COMMENTS ON THE DRAFT SCOPING REPORT OF THE PROPOSED KOTULO TSATSI ENERGY PV3 AND ASSOCIATED INFRASTRUCTURE, NORTHERN CAPE PROVINCE

ACCEPTANCE OF THE SCOPING REPORT FOR THE PROPOSED KOTULO TSATSI ENERGY PV3 FACILITY IN THE NAMAKWA DISTRICT MUNICIPALITY, NORTHERN CAPE PROVINCE

COMMENTS ON THE DRAFT SCOPING REPORT FOR THE PROPOSED KOTULO TSATSI ENERGY PV3 FACILITY, BESS AND ASSOCIATED INFRASTRUCTURE, NEAR KENHARDT, NORTHERN CAPE PROVINCE

ENVIRONMENTAL IMPACT ASSESSMENT FOR THE KOTULO TSATSI ENERGY PV3 AND ASSOCIATED INFRASTRUCTURE, NORTHERN CAPE PROVINCE

Scale: 1: 150 000
 Projection: WGS1984
 Map Ref: Kotulo Tsatsi Energy PV3 - Locality Map

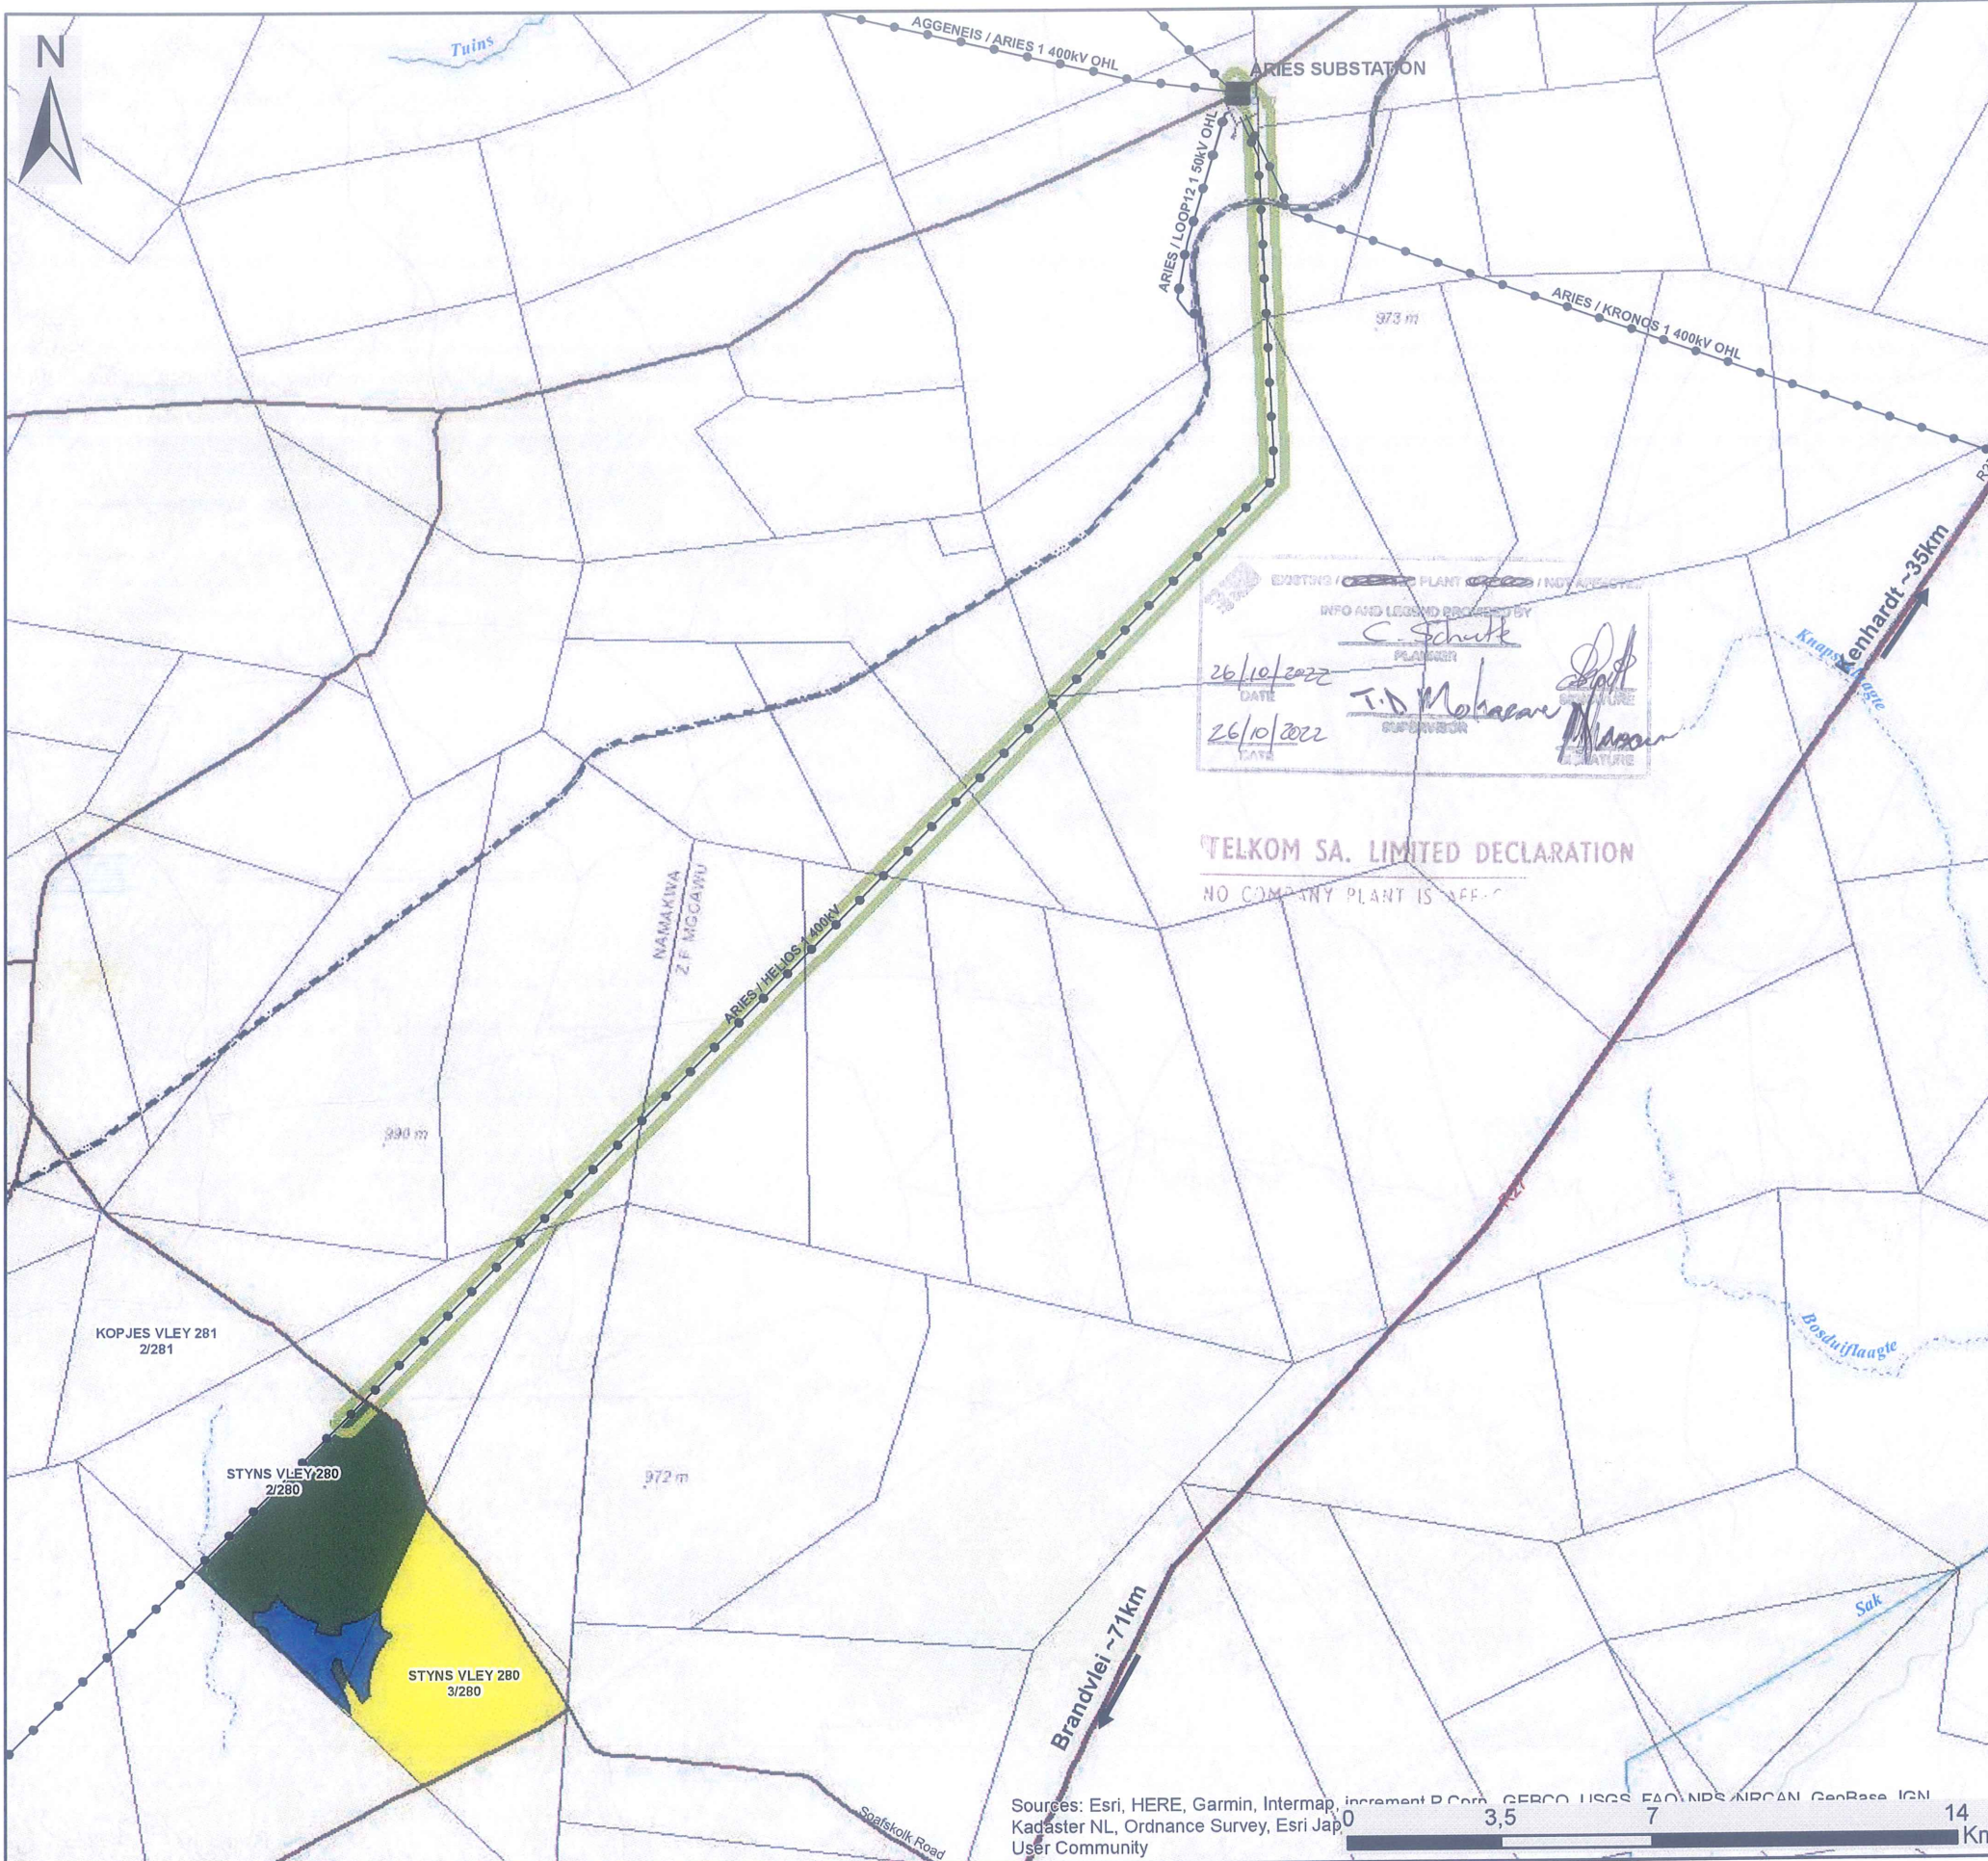
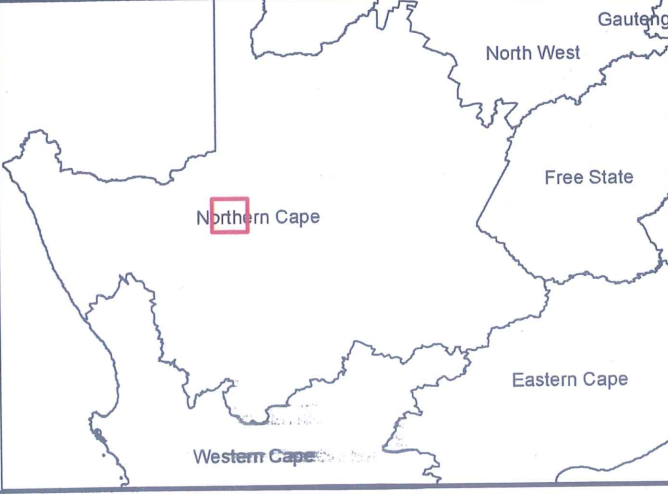
With reference to your above- mentioned application, I hereby confirm that the proposed work installation is approved in terms of Section 29 of the Electronic Communications Act No. 36 of 2005 as amended.

No infrastructure of our Client (Openserve) will be affected by this proposal. **We did our utmost to ensure that we indicate our route as accurate as possible and should you discover any of our cables that is not on the sketch please stop and contact us immediately to arrange a site meeting. In the event that our cables are exposed and damaged/stolen by a third party the damages will be repaired at the customer's account. Please make use of pilot holes in order not too damage our infrastructure.** Therefore any damages occurred during construction of work will be repaired at the customer's account.
